Section 7: Spent Fuel Pool Integrity Evaluation

7.1 Scope of the Seismic Evaluation for the SFP

Figure 7-1
Basic Process for Evaluation of Potential Failures for SFP Penetrations

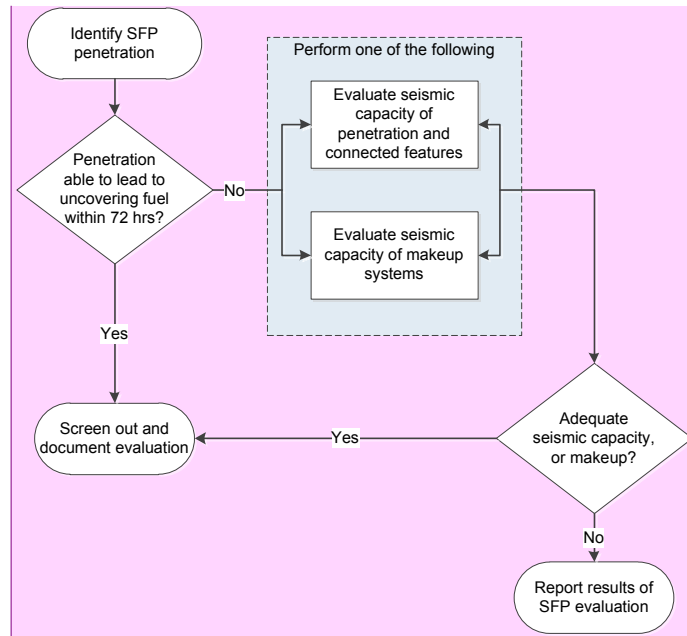
Comment [AK11]: The first set of yes and no are reversed. The arrows go both ways between the “perform one of the following” box and the “adequate seismic capacity” diamond. The arrows going into the box should be removed.
